**BLM Area B Track 2 Ponds
Geophysical Anomaly Investigation
Technical Information Paper
Former Fort Ord, California**

January 2020

Appendix A	Field Work Variance 021
Appendix B	USACE Geologist Photos
Appendix C	AGC Anomaly Investigation Dig Results
Appendix D	USACE QA Approval and Discussion
Appendix E	Responses to Comments

**Figure 6A
Pond 39
DGM and Dig Results**

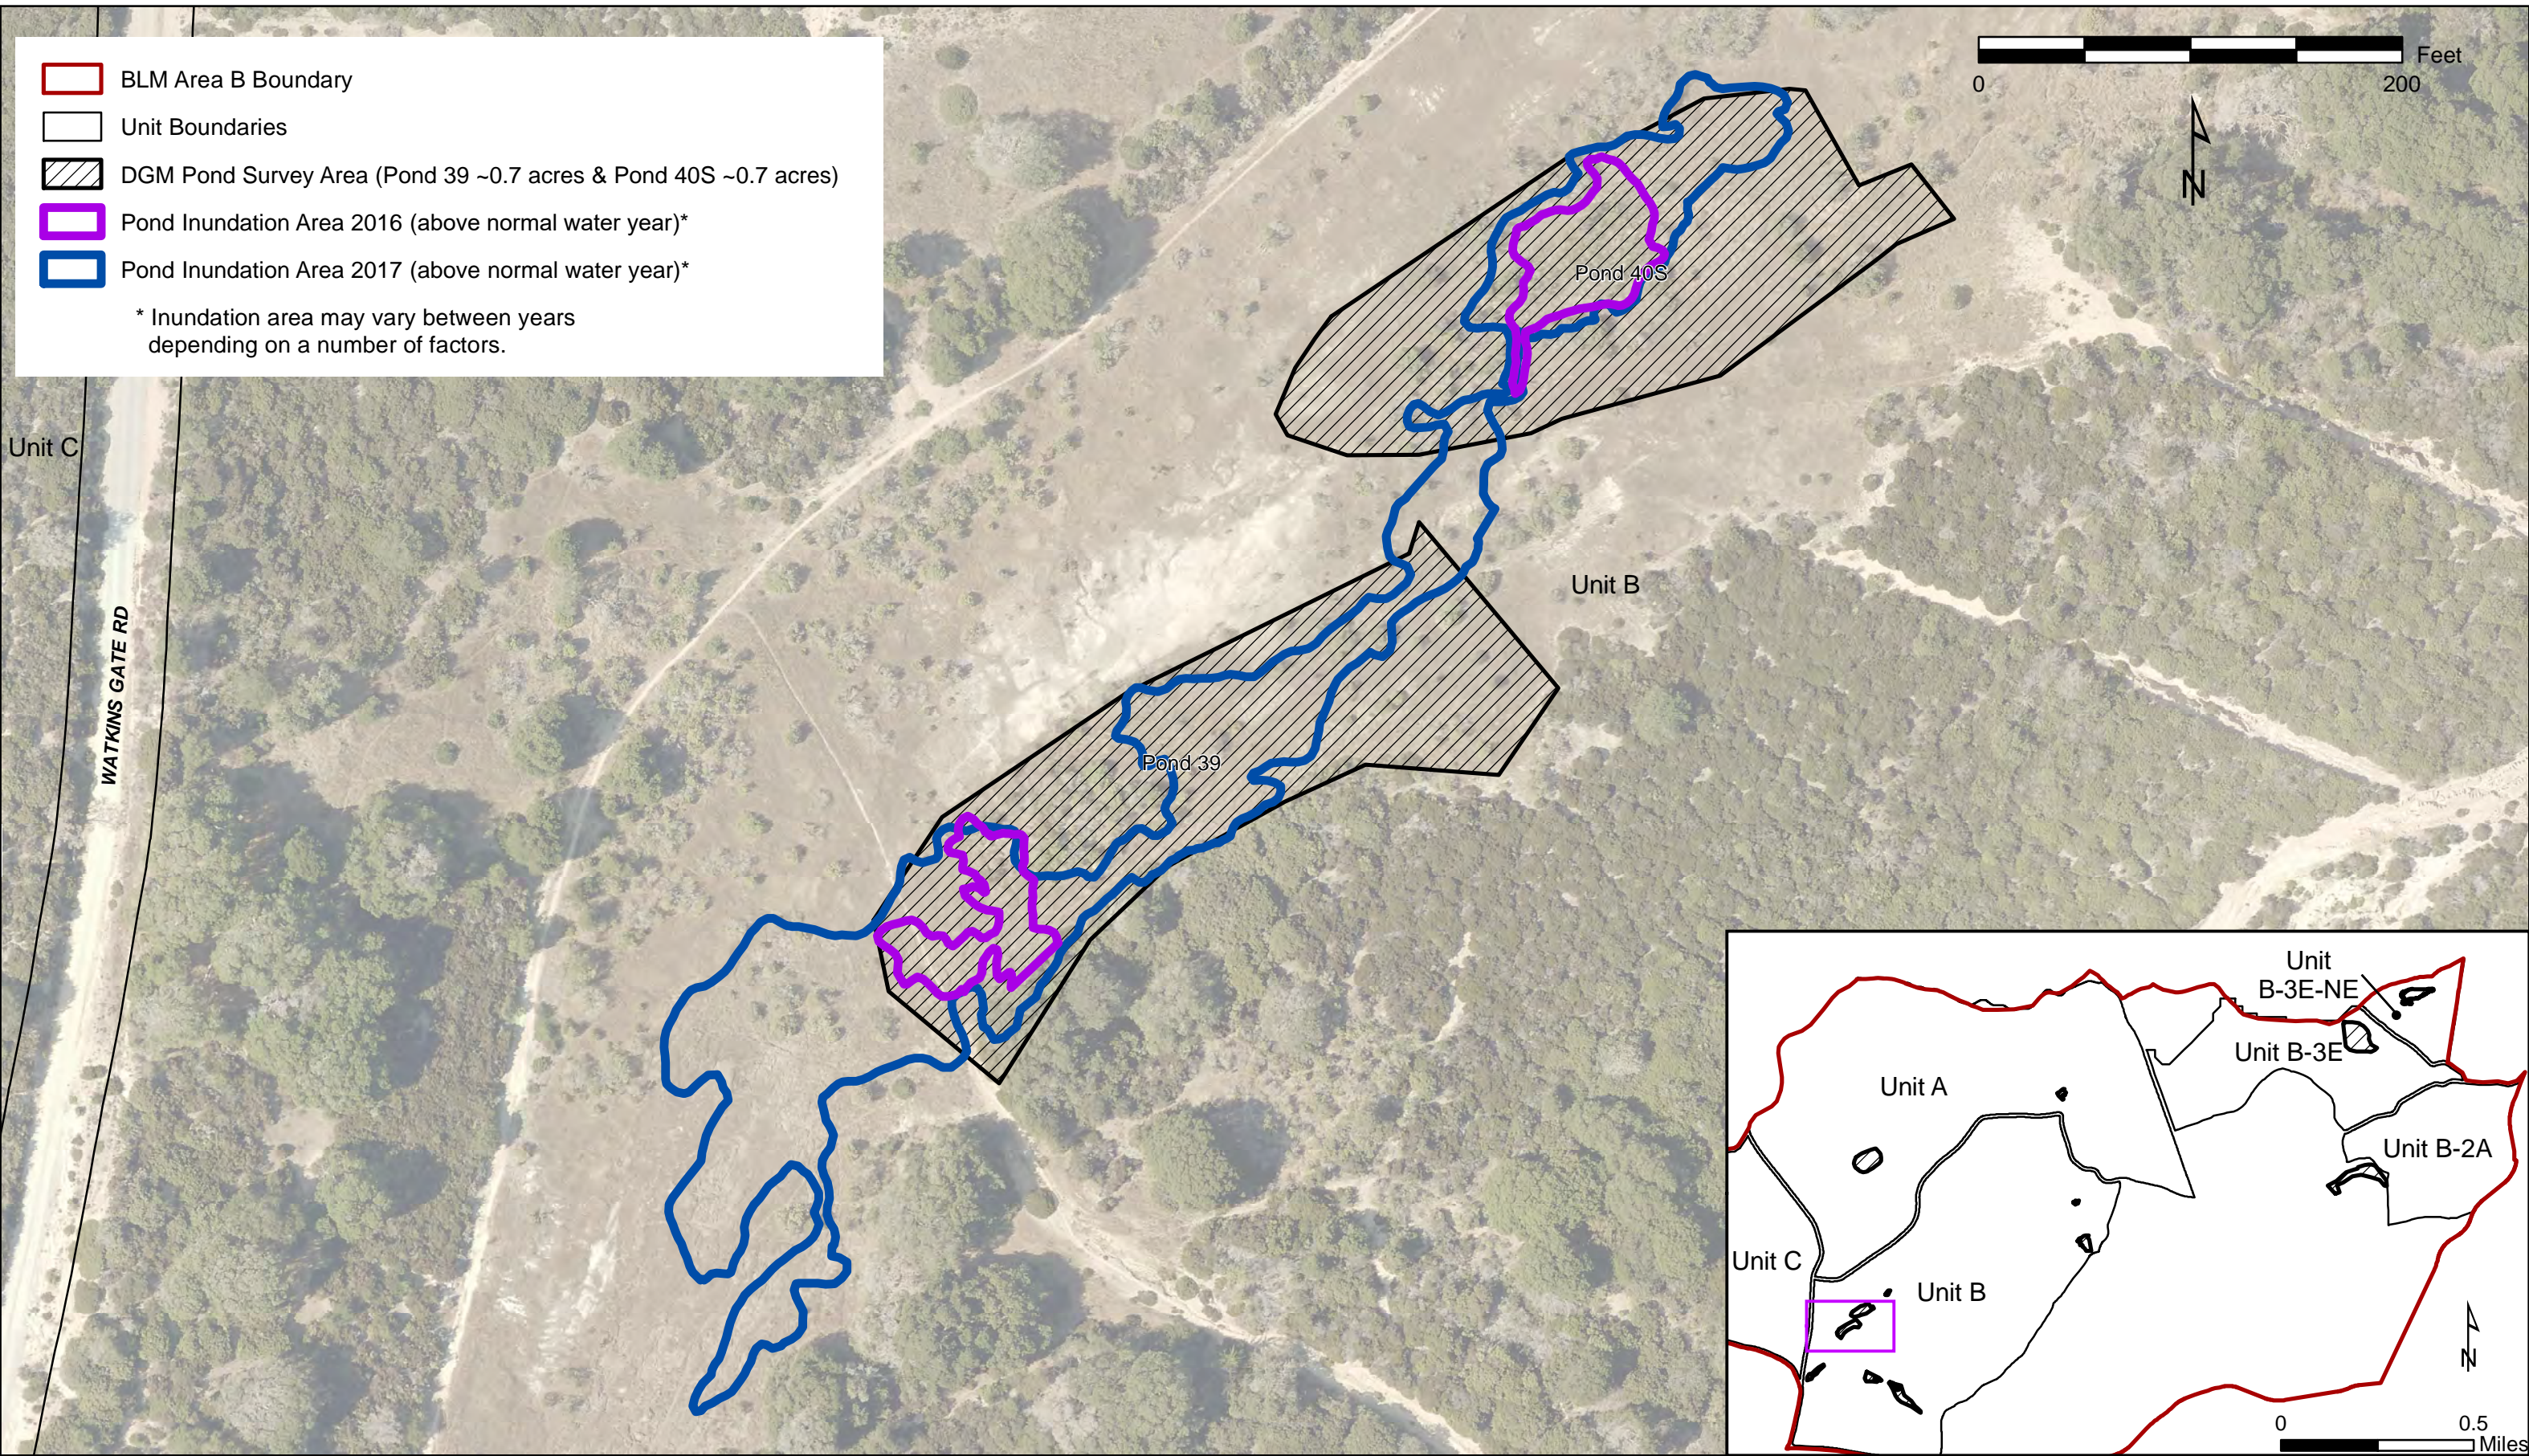
Figure 8A, Pond 40S DGM & Dig Results and Figure 6A, Pond 39 DGM & Dig Results: It is unclear why the red-shaded area northeast of targets 11 and 18 on Figure 8A were not identified as targets, since a similar area was identified as target 62 on FWV 21, Figure 5. There is a similar red-shaded area between two false positives on Figure 6A that appears to be between targets 62 and 92 on FWV 21, Figure 7. In both cases, the red-shaded areas appear to be about 14 mV on Figure 8A and 6A. Please explain why these red-shaded areas were not selected as targets.
